**El Segundo Power II LLC
El Segundo Redevelopment Project
(00-AFC-14C)**

Responses to CEC Data Requests Set 1

California Energy Commission

September 10, 2007

FIGURE 3.3-1
BARGE DELIVERY ROUTE

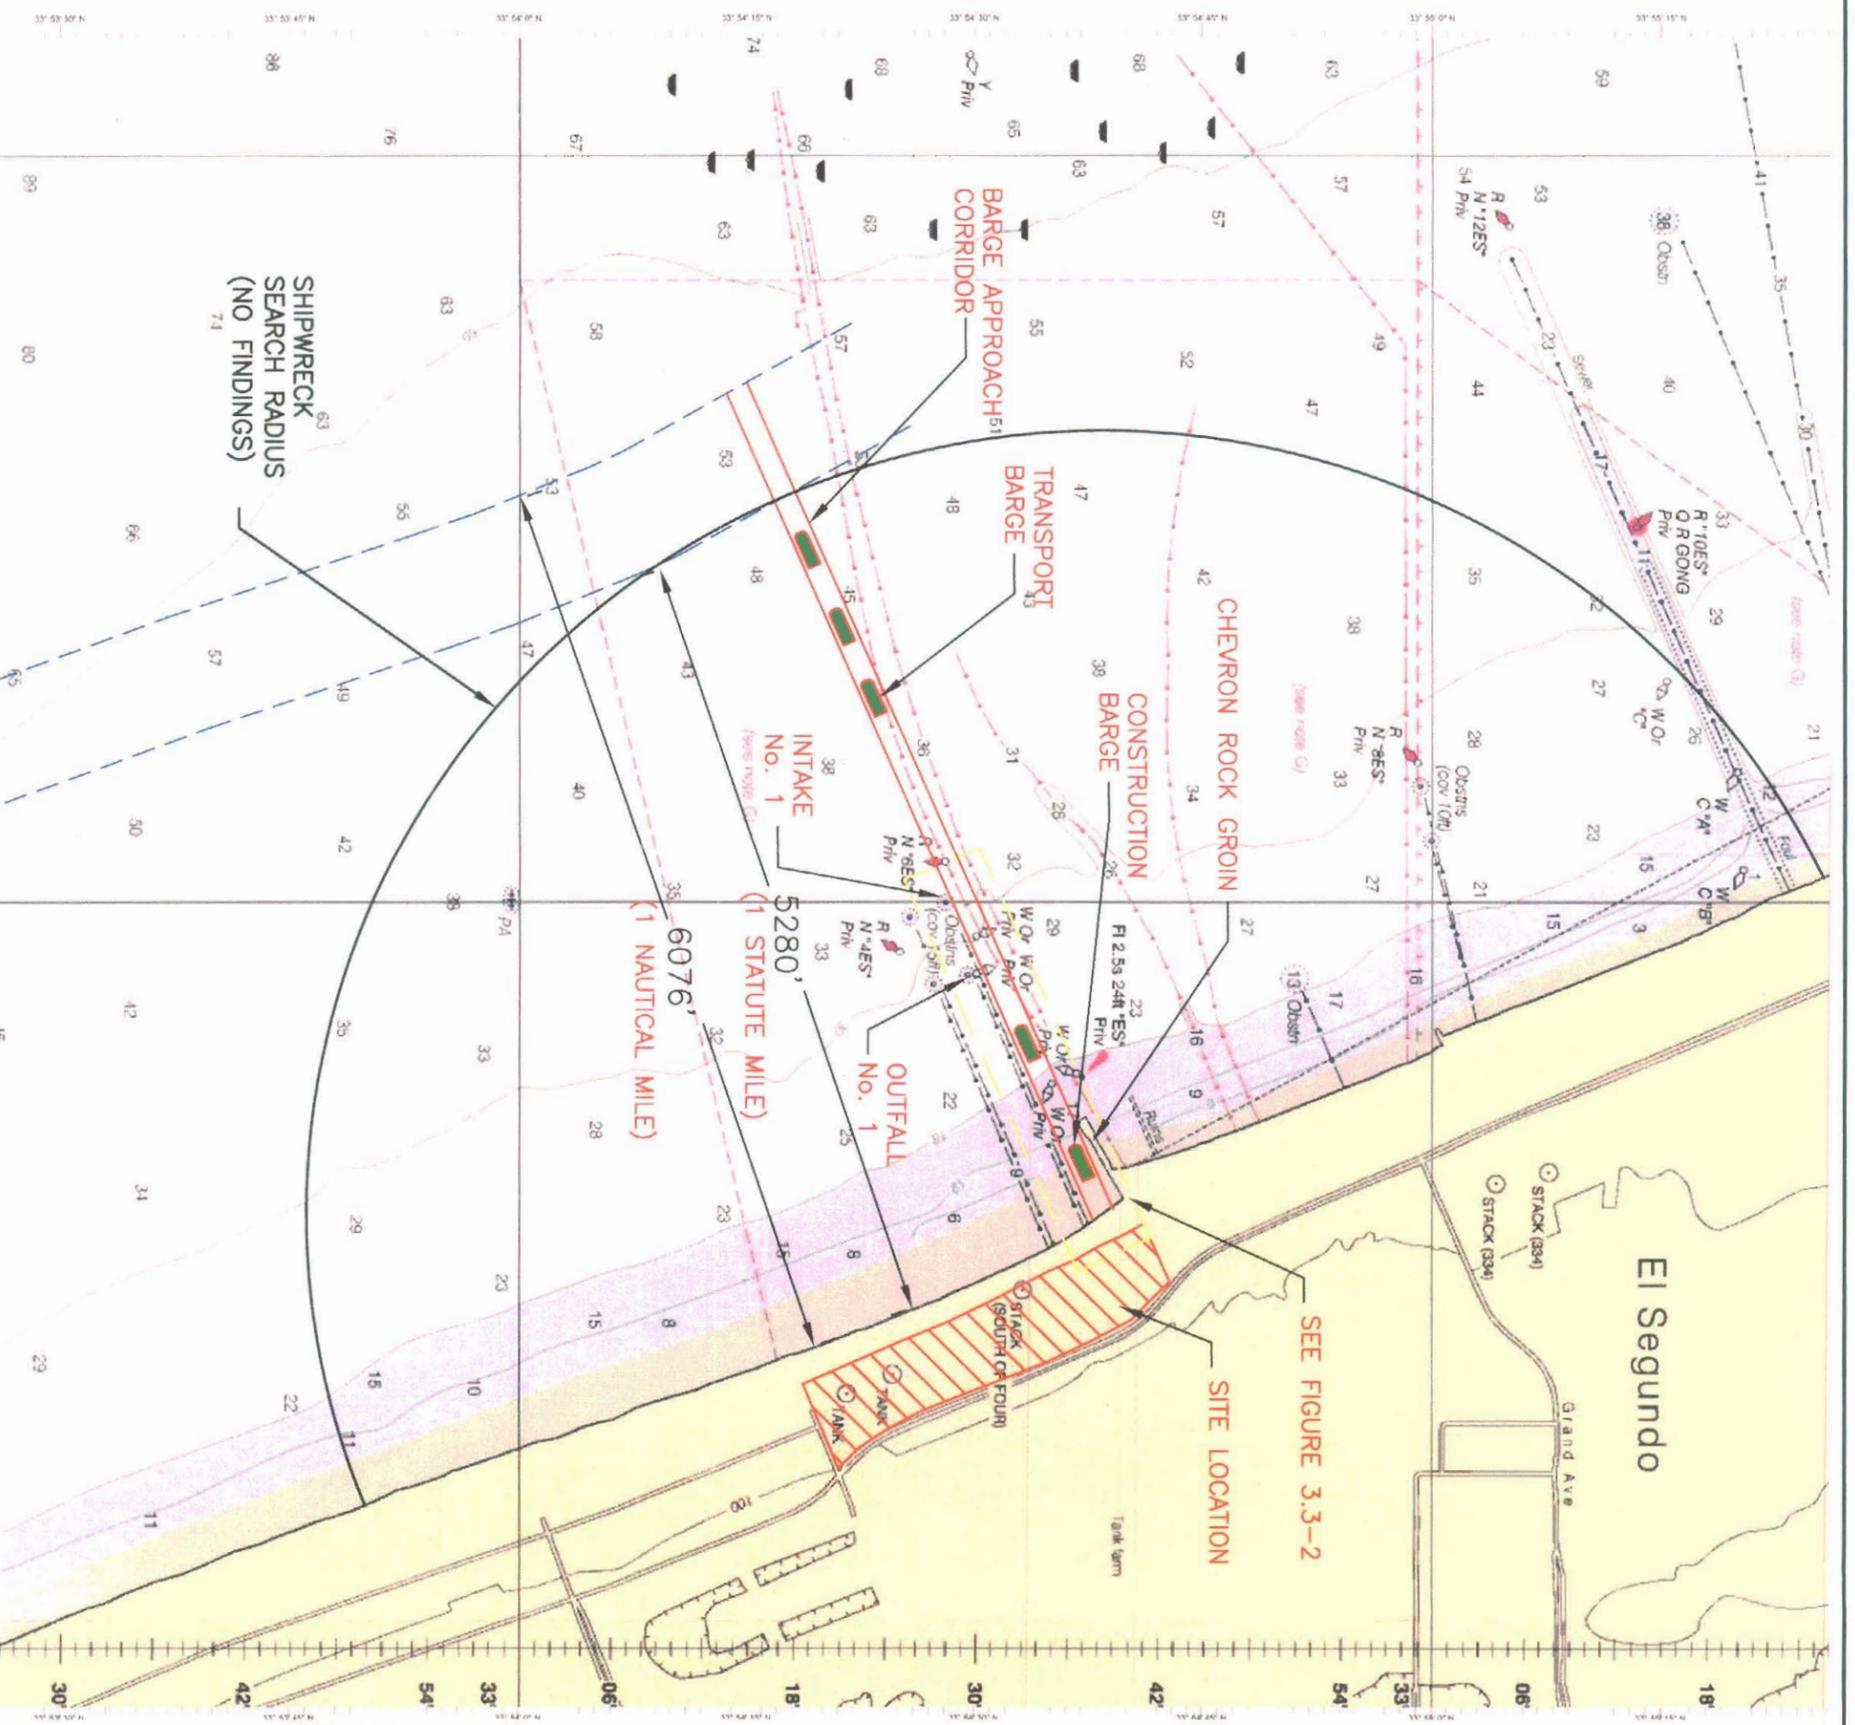
Data Request 2: Please provide a discussion of the depth of the ocean from the El Segundo shoreline opposite the power plant and out to one mile. Please provide figures or a discussion on how deep each kind of barge would typically sit in the water. Include depths for the barges when loaded and not loaded.

zone of 0-12 feet (Figure 2.2-1). Beyond this point, the depth abruptly increases to 18 feet and within approximately 0.5 mile from the beach the depth increases to 30 feet and within 1 mile of the beach, the depth is estimated to be approximately 53 feet.

Figure 3.3-1 depicts the depth in feet at mean lower low water (MLLW), approximate location, and path the delivery barges within 1 nautical mile of the shore line of ESGS. Figure 3.3-1 is based on National Oceanic and Atmospheric Administration (NOAA) nautical chart last updated June 2007. The barge approach area is noted by NOAA as an area with numerous submerged pipelines, sewer lines, and other potential hazards and recommends using the most direct route when transiting or anchoring in the area. ESPR has performed a higher resolution bathymetry survey in September 2006 from the El Segundo shore line out half a mile offshore to identify submerged obstacles. Figure 3.3-2 shows the results of the bathymetry survey and the intended barge approach route. Other than the Chevron rock groin the most prominent subsurface feature in the barge approach route are the El Segundo Generating Station intake and outfall structures No. 001 and No 002. The structures are shown in Figure 3.3-2 in waters approximately 30 to 35 feet deep with the top of the intake and discharge structures at 22 to 28 feet MLLW. Red buoys mark the location of these structures offshore and nautical charts show the minimum water cover is 15 feet over the structures at MLLW.

Figure 3.3-1 shows the area one-mile north, south, and west of the ESPR site.
